Model: Finisher SR3230, SR3240		Date: 26-May-16	No.: RD3BA002
Subject: Accessory trays of other models		Prepared by: Y.Ino	
From: 1st Tech Service Sect., MFP/P Tech Service Dept.			
Classification:	<input type="checkbox"/> Troubleshooting <input type="checkbox"/> Mechanical <input type="checkbox"/> Paper path <input type="checkbox"/> Product Safety	<input type="checkbox"/> Part information <input type="checkbox"/> Electrical <input type="checkbox"/> Transmit/receive <input checked="" type="checkbox"/> Other (Information)	<input type="checkbox"/> Action required <input checked="" type="checkbox"/> Service manual revision <input type="checkbox"/> Retrofit information <input type="checkbox"/> Tier 2

Subject: Poor stacking of stapled job		Prepared by: Y.Taniguchi	
From: 1st Tech Service Sect., MFP/P Tech Service Dept.			
Classification:	<input checked="" type="checkbox"/> Troubleshooting	<input type="checkbox"/> Part information	<input type="checkbox"/> Action required
	<input type="checkbox"/> Mechanical	<input type="checkbox"/> Electrical	<input type="checkbox"/> Service manual revision
	<input type="checkbox"/> Paper path	<input type="checkbox"/> Transmit/receive	<input type="check

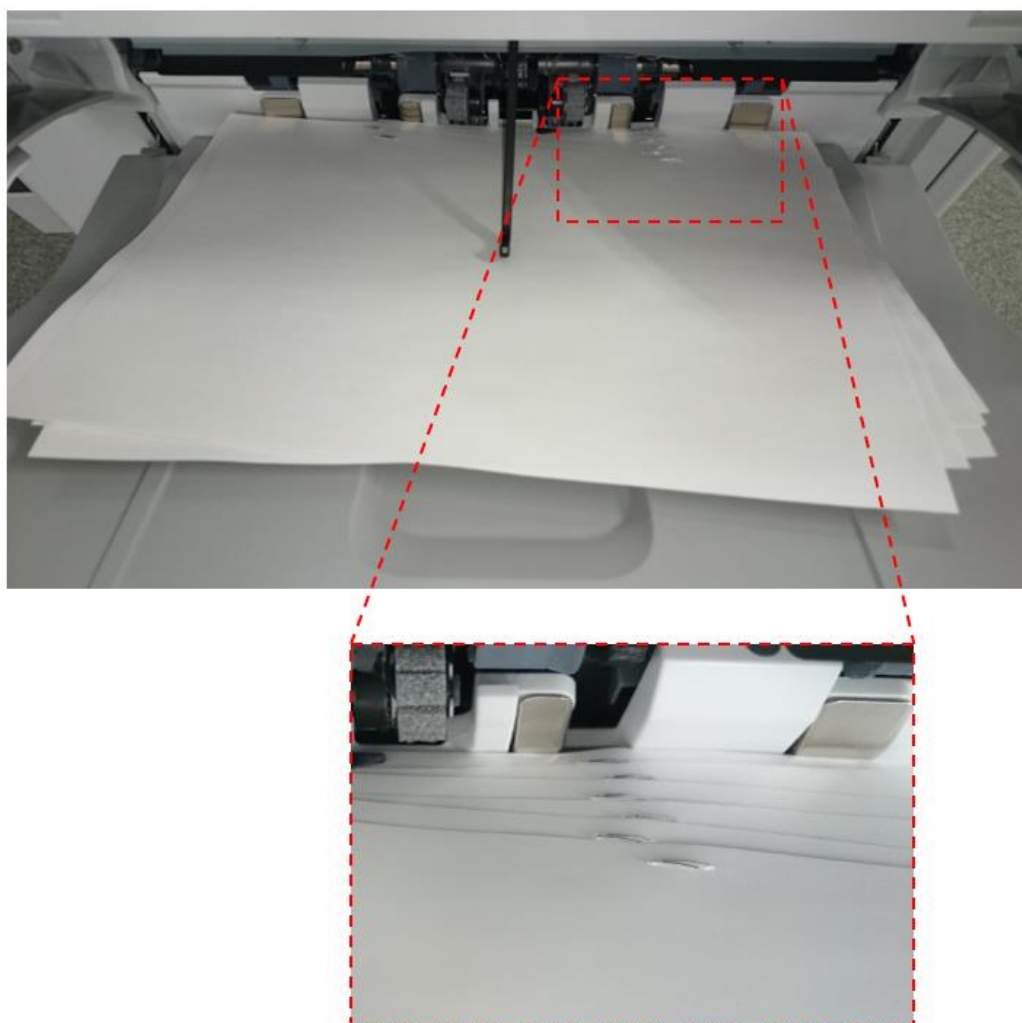
Stapled booklets are misaligned in the exit tray as shown below.

A4 booklets (2 sheets x 50), fed LEF, stapled at corner

Stapled jobs are not fed out at the correct speed. Specifically, they are fed out faster than on predecessor finishers (SR3160/SR3170).

As a result, booklets tend to be pushed farther out when fed out. When each booklet then slides back down to settle into the stack, its trailing edge catches on the staple of the booklet already stacked underneath it. This happens with several booklets many times in a row, producing the type of staggered alignment shown in the photo above.

The Finisher firmware was modified so as to optimize the speed at which the booklets are fed out (Applied from: May 2016).

Update the Finisher firmware to **ver.1.050.07** or newer.

Note: *This firmware prevents the misalignment from continually occurring, i.e. on several booklets many times in a row. The booklets may still catch on the staple intermittently a few times.*

Example: Two sheets protruding from a stack of 50.

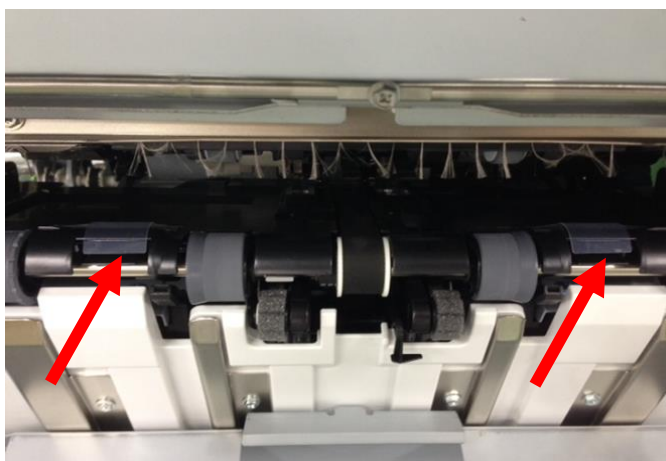
One or more sheets (A4/LT or smaller) protrude from the stack when the sheet(s) are fed out to the tray late.

The edge of the guide Mylar protrudes over the paper exit roller.

When the affected sheet(s) are fed out to the tray late, the paper rides up on the guide Mylar. As a result, the sheet(s) are then pushed by those behind them.

Re-attach the guide Mylar (see **PROCEDURE** below).

Fig. 1: Attachment position

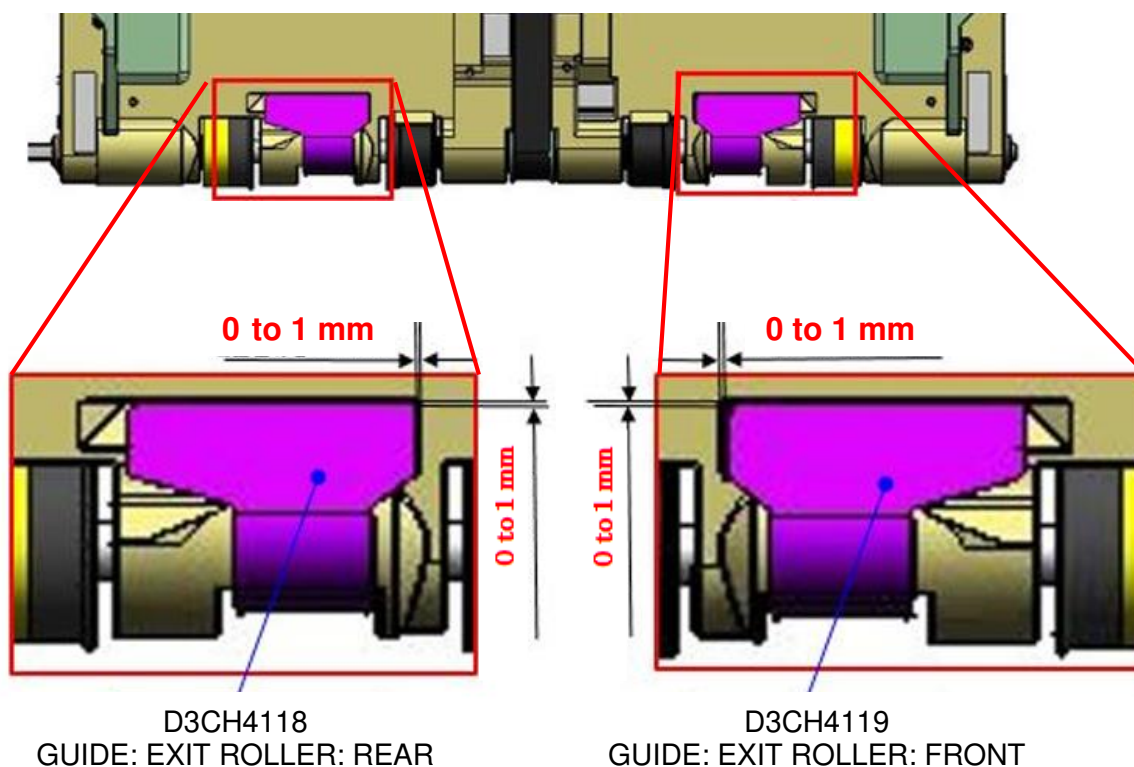
- Attach the new Mylar in the position shown (**Fig. 1**).
- Make sure not to directly touch the adhesive surface of the Mylar.
- Press the long and short edges of the Mylar (edges 1 and 2 in **Fig. 2**) flush against the recessed grooves in the frame, and then press down on the adhesive surface to attach.

Moving the Finisher

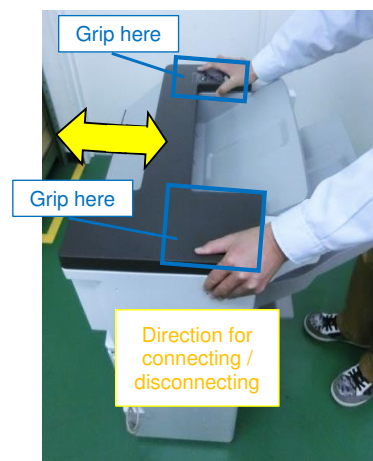
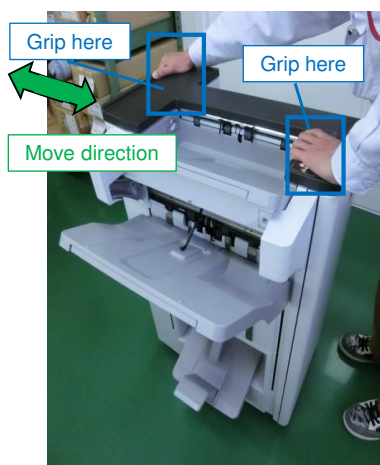
The procedure on how to properly move the Finisher was added to the Service Manual.

- As a general rule for moving the finisher, move it from the front to the rear of the machine as indicated with the arrows in green, by gripping the positions outlined in blue in the photo below.
- Make sure to grip both front and back of the finisher at the top to prevent the unit from tipping over.
- When connecting or disconnecting the finisher to or from the main frame, slightly move it in the direction indicated with the yellow arrow.

When the finisher has to be lifted up, for instance, when moving it over an object on the ground, hold the bottom frame. DO NOT hold the ground plate.

Do not grip the following locations when moving the finisher:

- Proof tray
- Entrance guide plate
- Front and rear covers
- Shift tray base
- Connection lever
- Waste punch full detection sensor bracket
- Booklet stapler unit (SR3240 only)
